NUCLEAR REGULATORY COMMISSION

Title: Advisory Committee on Reactor Safeguards
 Regulatory Policies and Practices

Date: Monday, September 16, 2013

- ACRS comments on MACCS2 weather uncertainty integration and convergence of results, and staff responses
- MELCOR parameters of interest
- MACCS2 parameters of interest

Run 1 (CAP17) Conditional, Mean, Individual LCF Risk (per Event) CCDF with LHS and MC Sampling

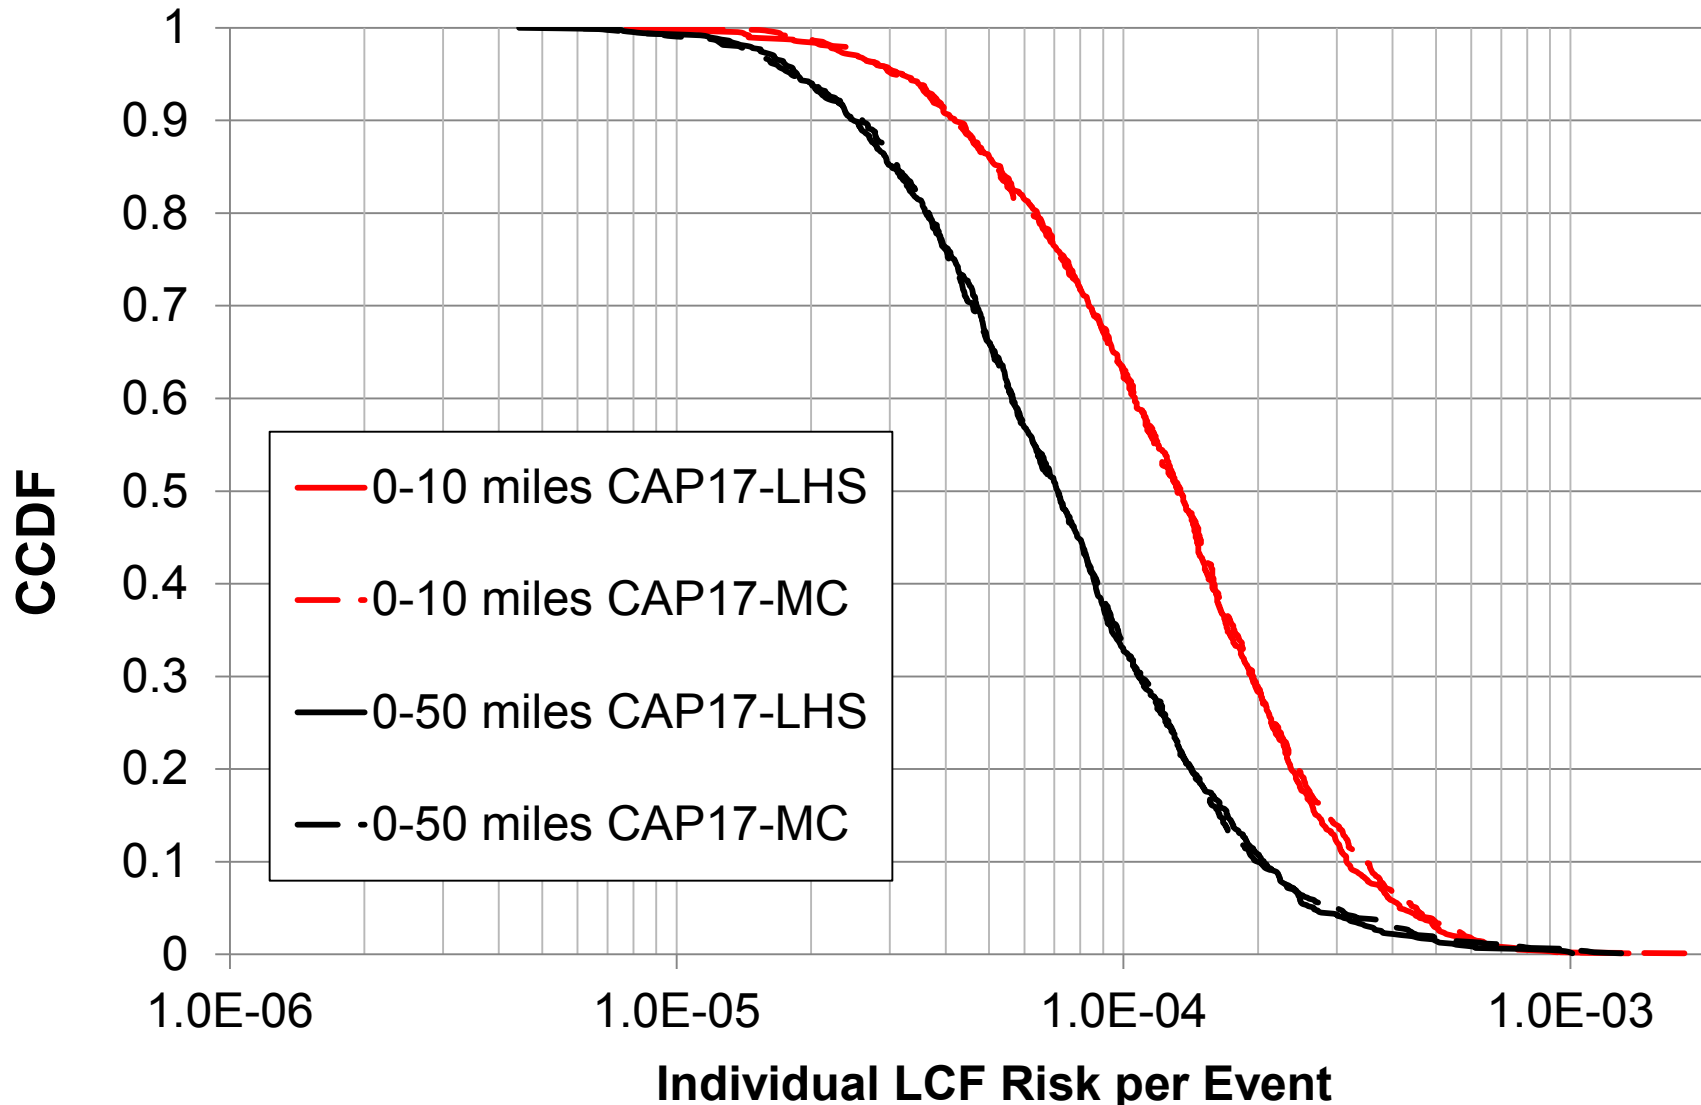
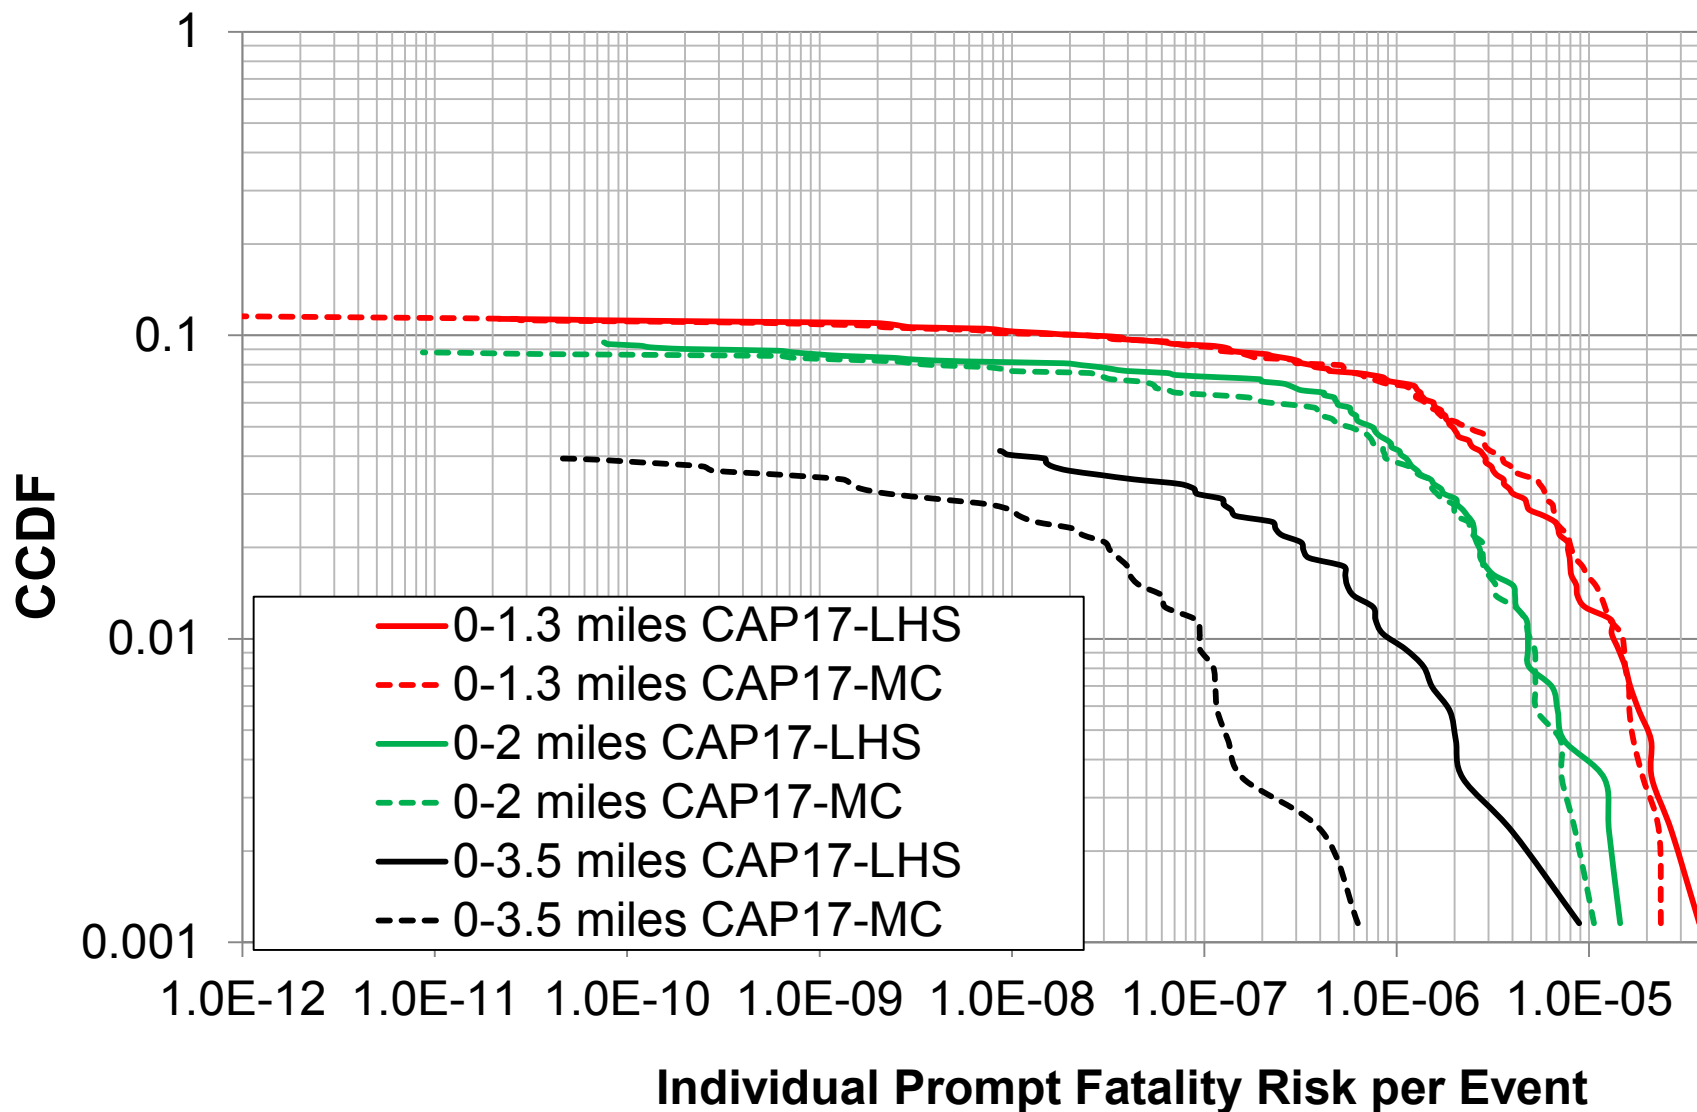
19 DR. GHOSH: So the question came up a lot
20 in the past discussions - some of it online, some of it
21 offline - about why do we keep using Latin hypercube
22 sampling and, you know, I guess one school of thought is
23 not very fond of Latin hypercube sampling.

Approach:

- MACCS2 code modified to allow simple random sampling
- The 'high' source term (i.e., Replicate 1 Realization 290) and the SOARCA UA MACCS2 Analysis (Run 1) were selected to compare between Simple Random Sampling (SRS or MC) and Latin Hypercube Sampling (LHS) in order to validate the use of LHS
- Bootstrapping performed (similar to approach with MELCOR results) to estimate confidence bounds
- Conclusion: Results of the uncertainty analysis are well converged and LHS use is valid

SRVOAFRAC – SRV open area fraction

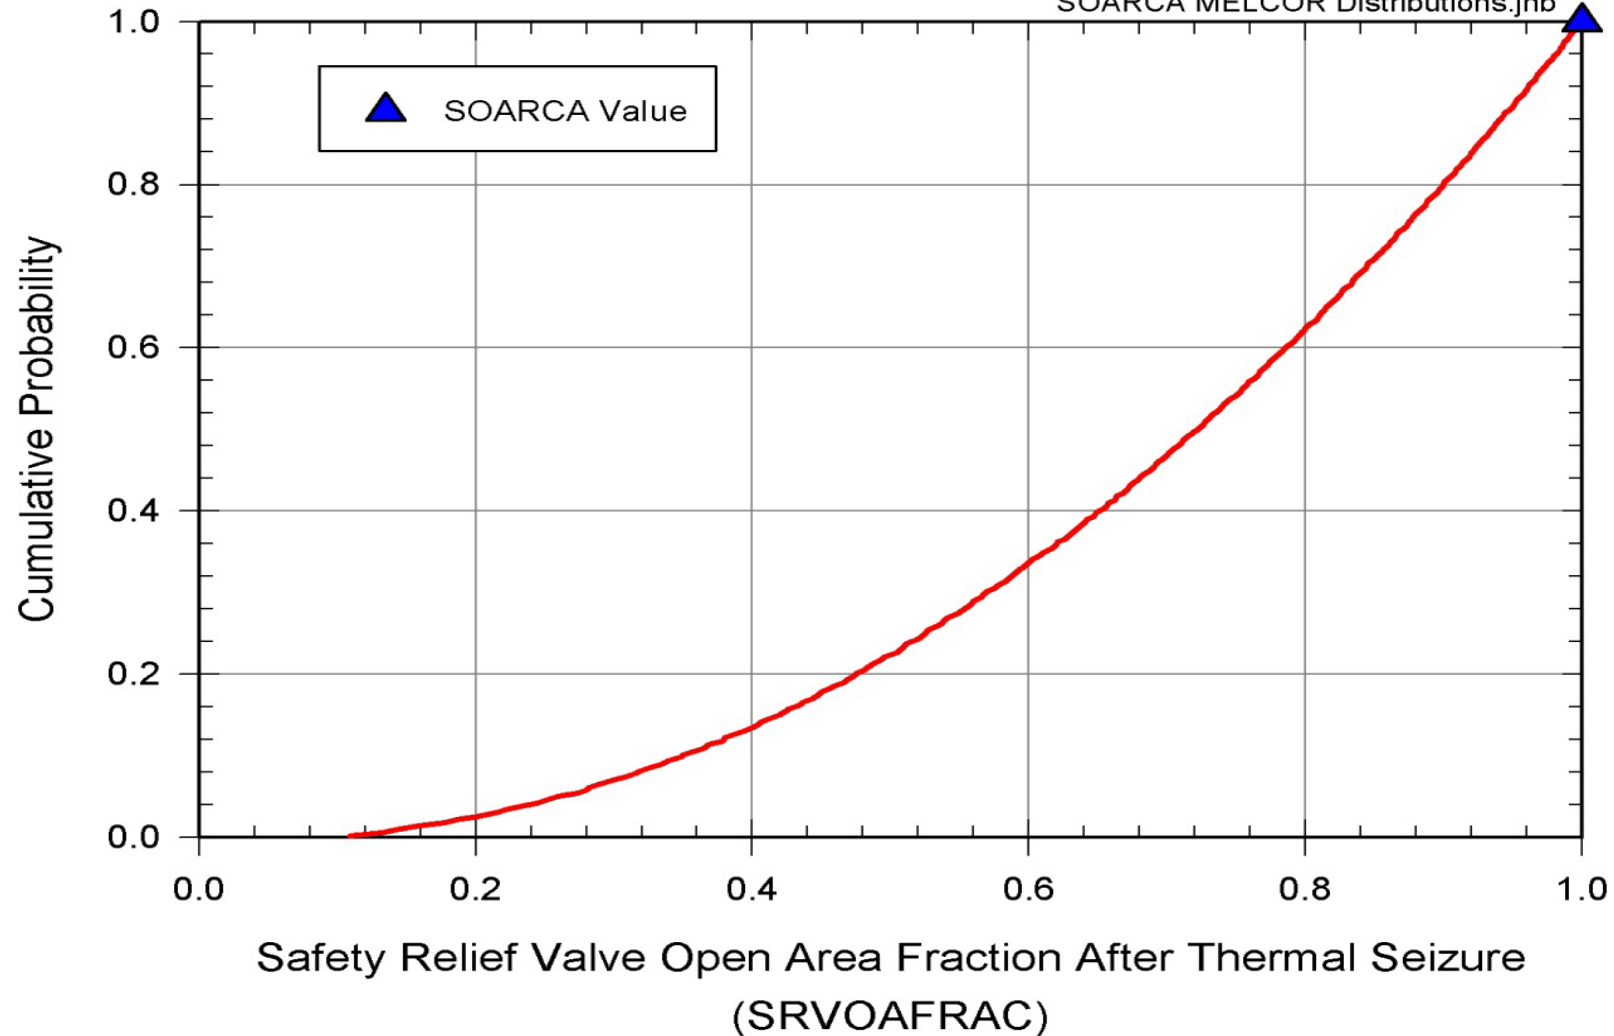
8 The curve that we're looking at, Kyle, on
9 - I'm assuming you have the handouts - is on sheet 37 of
10 the presentation. That curve shows a probability
11 distribution for the open fraction.

12 CHAIRMAN STETKAR: Yeah. The analysis was
13 based on the curve that we have on sheet 37, right?
